PROGRESS REPORT

Independent Review of Implementation of Revised Seismic Design Criteria Hanford Waste Treatment and Immobilization Plant (WTP)

Revision D

U.S. Army Corps of Engineers
Walla Walla District

Figure SM-75-1 In-Plane Shear Stresses at Wall at line B of HLW, between 12 & 12.1 due to NS seismic

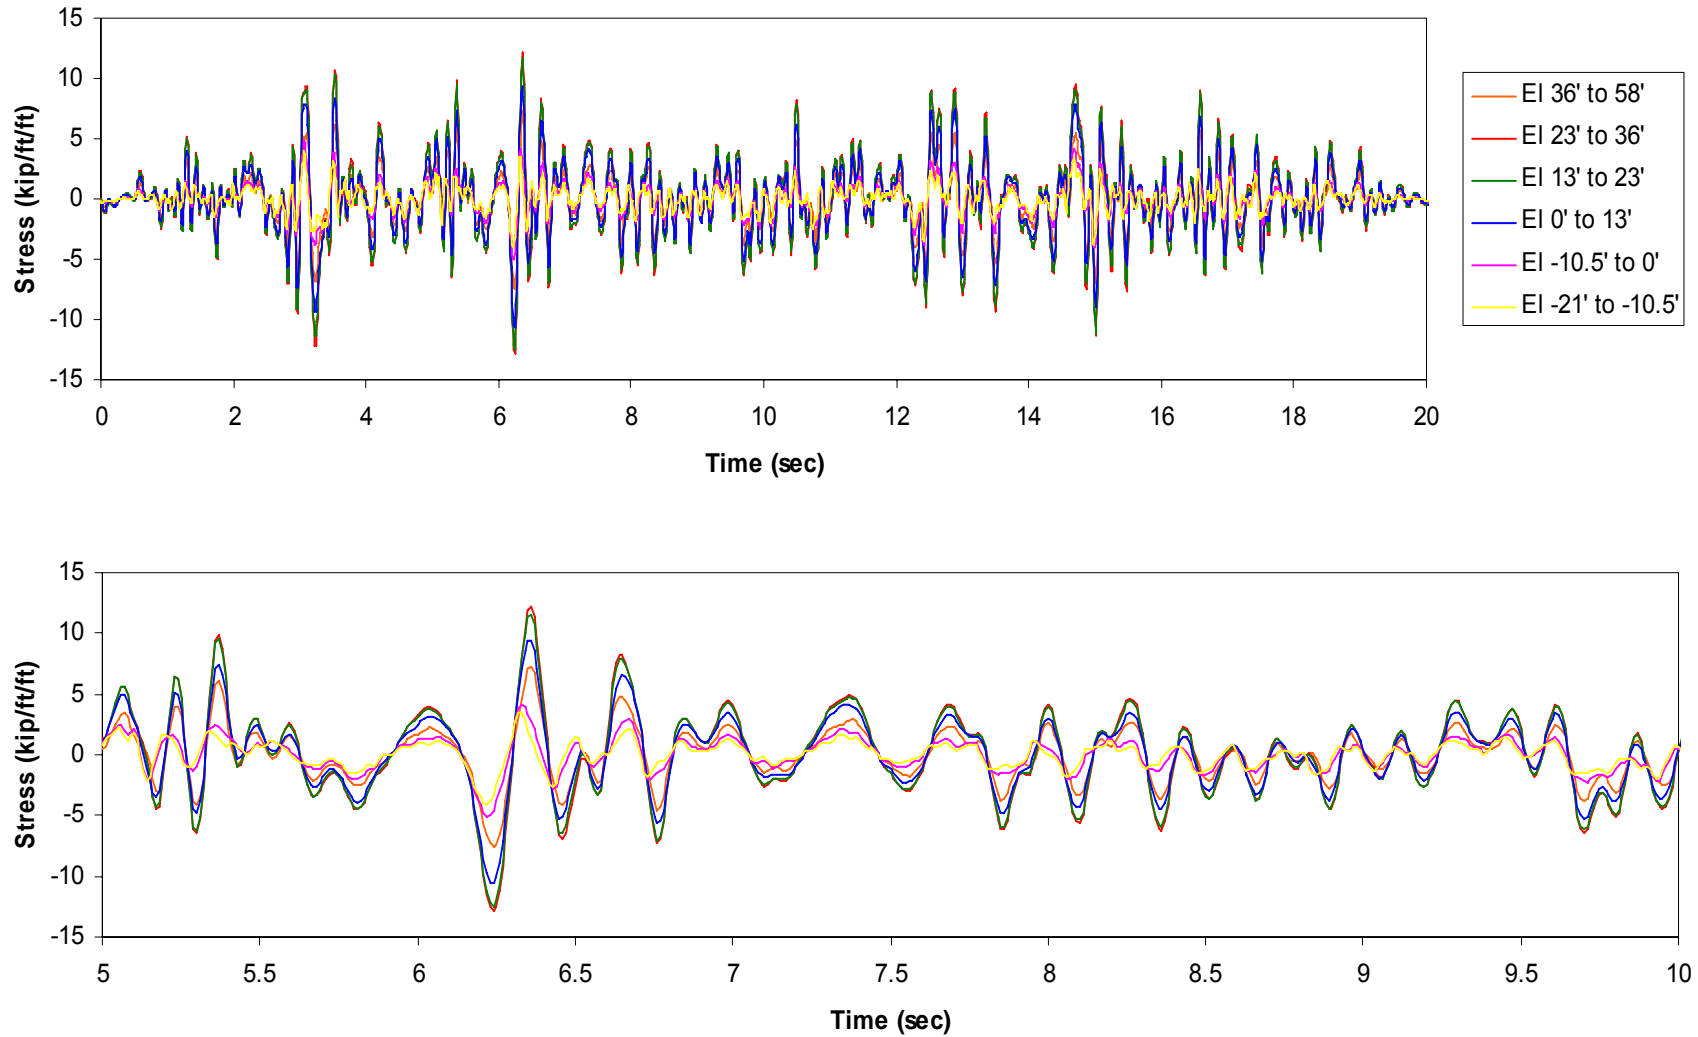
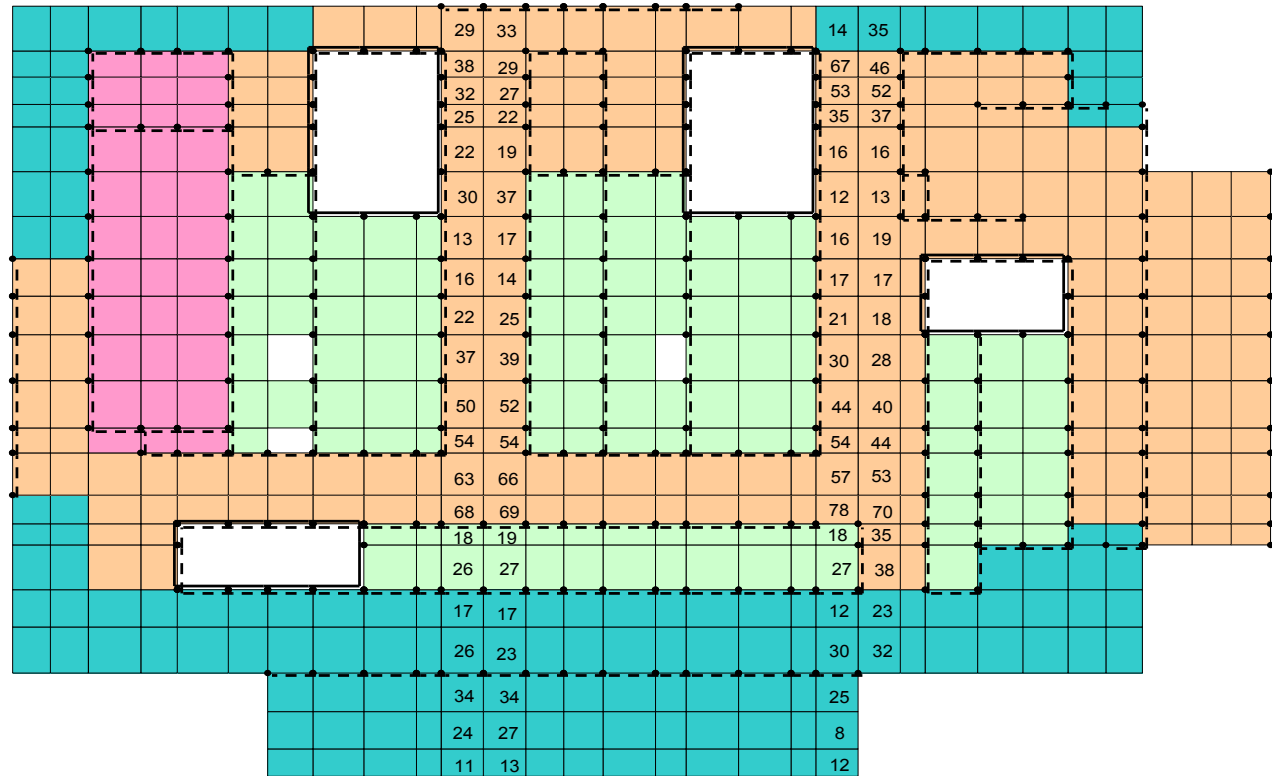
C.2 Structural Modeling Review Comments Phase II				
No.	Document	Comments and Observations	BNI Remarks/ Resolutions	Follow-up by USACE Review Team
			<p>relative displacement between adjacent walls. Table SM-75-1, attached, summarized and compared in-plane shear stresses of stripes of slab at elevation 57' calculated by SASSI SSI analyses and by the statically applied equivalent seismic load. The comparison shows the relatively low shear stresses calculated by static analysis are higher than those calculated by dynamic analysis using SASSI. Figure SM-75-2, attached, shows location of these slab elements.</p> <p>In conclusion, each major shear wall in HLW has its own frequency of vibration in the horizontal in-plane direction, and the statically in-phase application of the equivalent seismic load is conservative. For reinforced concrete slabs that are connecting various shear walls together, horizontal seismic is the only primary contributor to the in-plane shear stresses. Since the statically calculated shear stresses are lower than those from dynamic analyses, and since their absolute magnitudes are small relative to shear capacity of concrete, it is concluded that the static application of seismic loads is adequate in terms of out-of-phase motion in HLW.</p>

Figure SM-80-1 Comparison of Strain Compatible Sv between Revisions 0 and 2 of PTF Free Field Analysis Calculation (#24590-PTF-S0C-S15T- 00001)

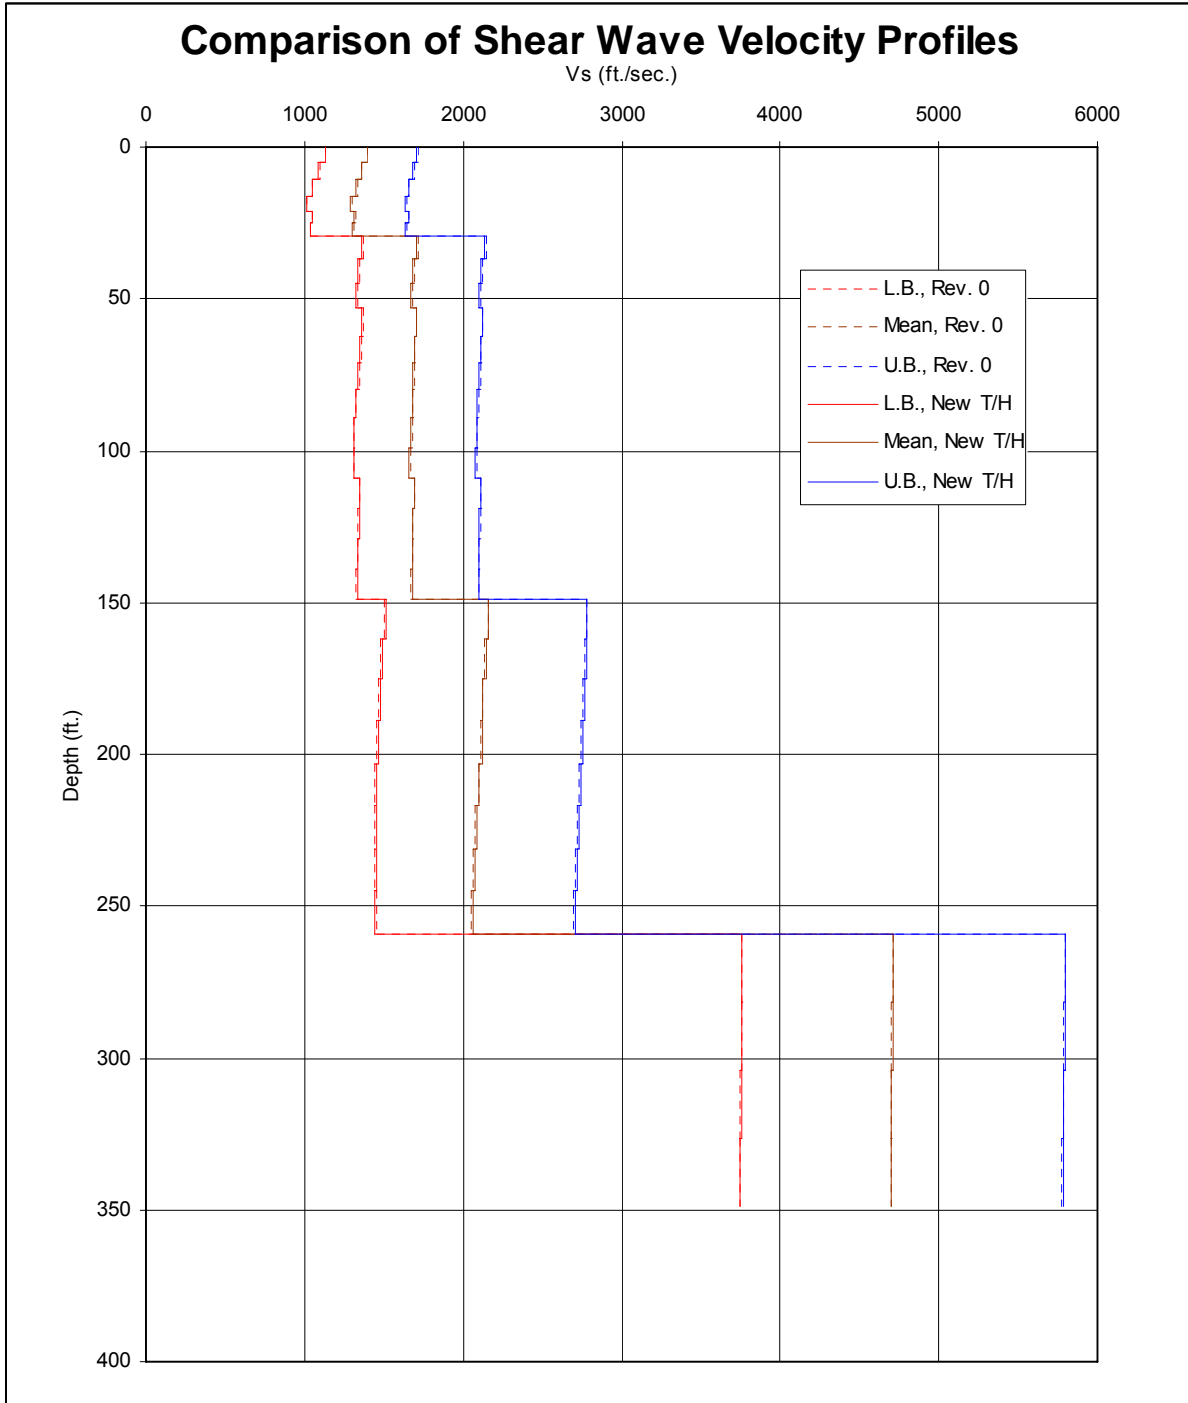
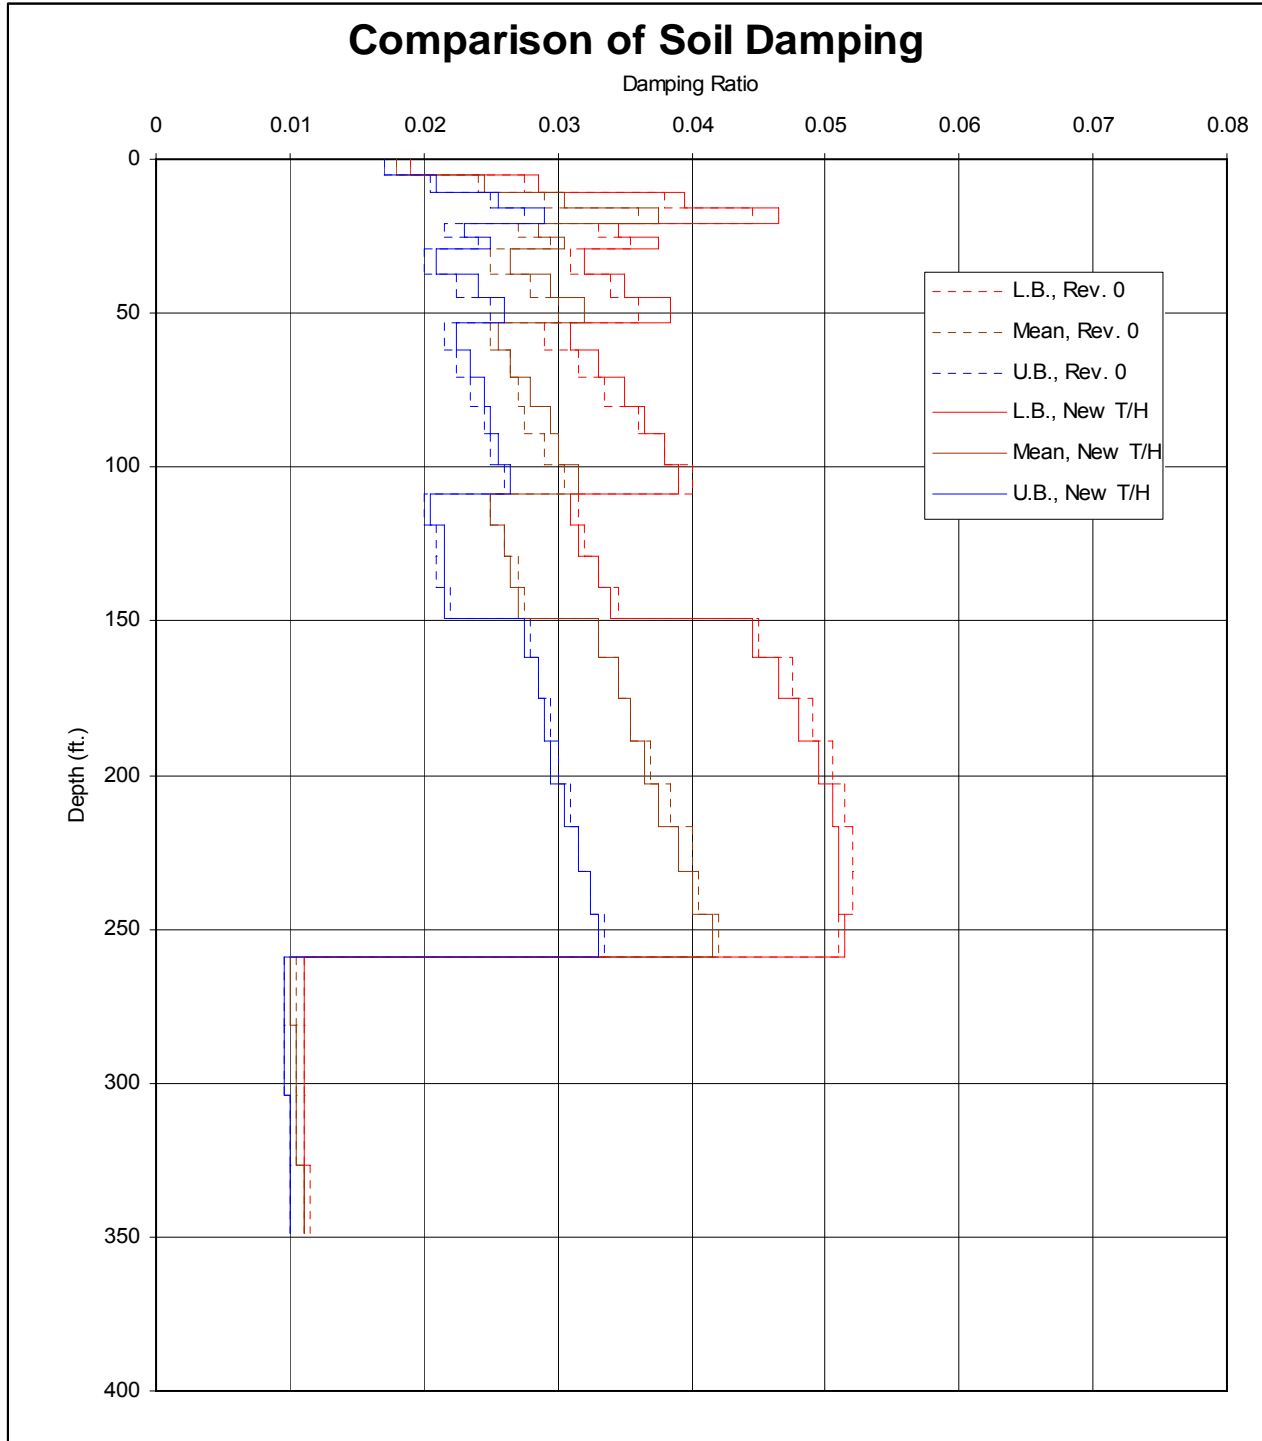
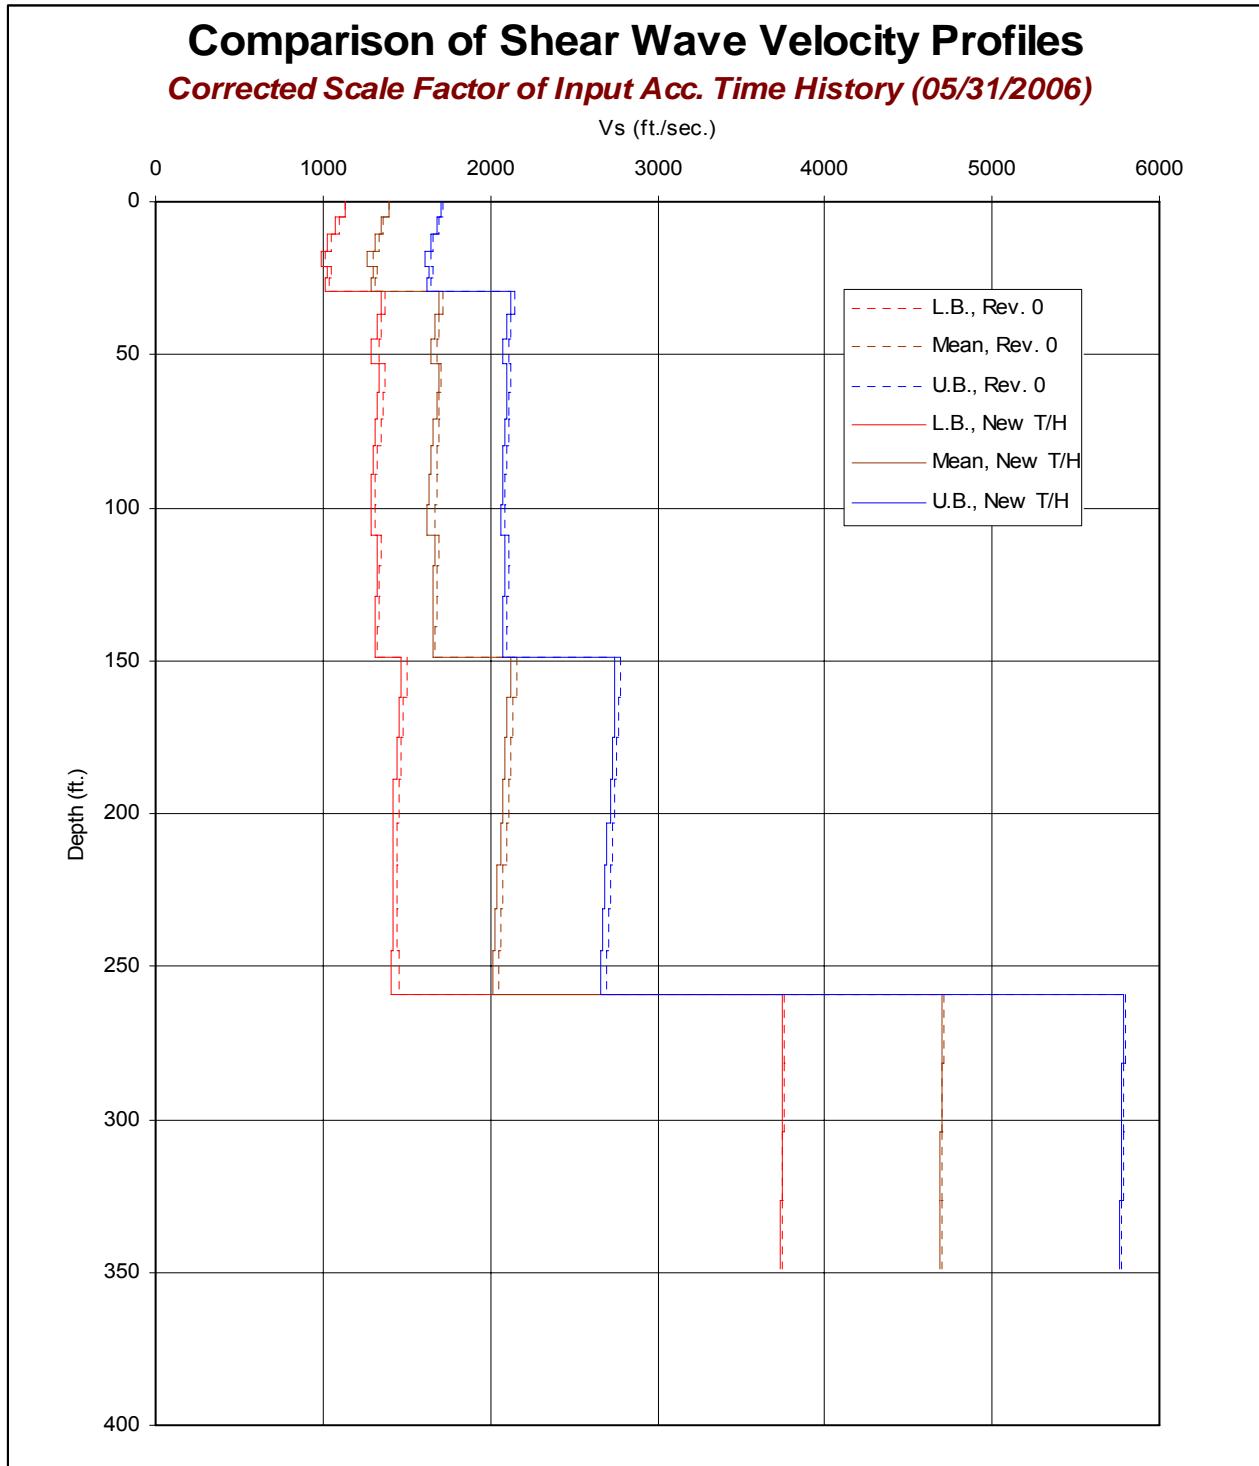
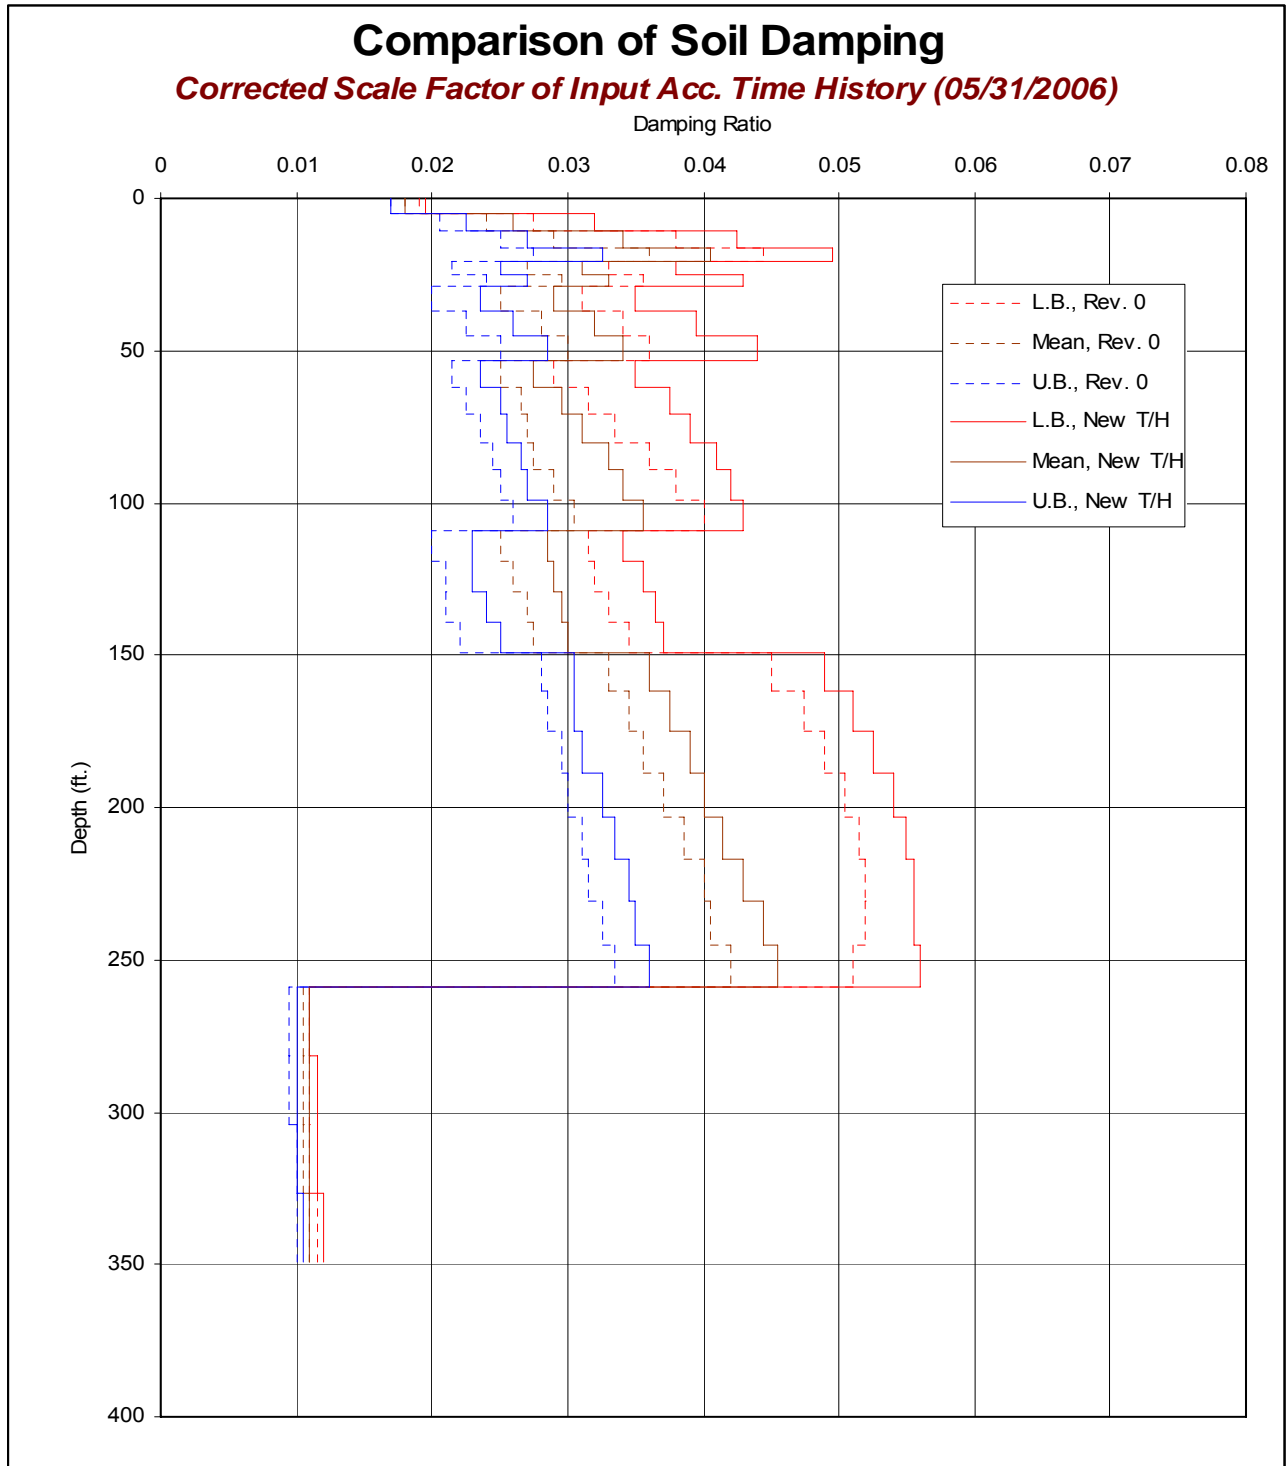
C.2 Structural Modeling Review Comments Phase II				
No.	Document	Comments and Observations	BNI Remarks/ Resolutions	Follow-up by USACE Review Team
	5. 24590-PTF-S0C-S15T-00010, Rev.1, Pretreatment Building – Soil Springs.		<p>wave velocities and soil damping values used in SSI analyses are based only on data from revision 1 of reference #1 calculation and from data given in reference #3 ORP letter, this change in PGA is concluded to have no impact to the SSI analyses of PTF.</p> <p>(2) Soil damping calculated by SHAKE analyses are shown in Figures SM-80-2 and SM-80-4. They are calculated by de-convolution with input time history motions applied at top of soil. In general, relative to the overall damping in the SSI analyses, these damping values are small and would not have much impact on the calculated SSI responses. Reference #3 ORP letter gives additional sets of soil damping which are calculated with the determination of ARS of input motion at grade where Convolution method was used. The shape of the soil damping of the soil column are different between convolution and de-convolution methods.</p> <p>Since the SHAKE calculated soil damping values are relatively small which would have only small effects on SSI analyses, and since those soil damping given in reference #3</p>	<p>analysis, i.e., shear modulus and damping for strain compatible conditions. This is not the case when damping is extracted and used from the seismic hazard analysis and shear moduli are determined from the SHAKE analyses.</p> <p>On the issue of conservatism, for the embedded structure HLW, higher damping values likely leads to more conservative results due to kinematic interaction and less conservative results due to inertial interaction. For the PTF building, the results are likely to be less conservative due to inertial interaction since there is no embedment of significance (no kinematic interaction effects). One cannot argue conservatism or insignificance effectively without sensitivity studies to verify it.</p> <p>This issue remains open, but is the responsibility of DOE since they specified which soil material damping values the project should use.</p>
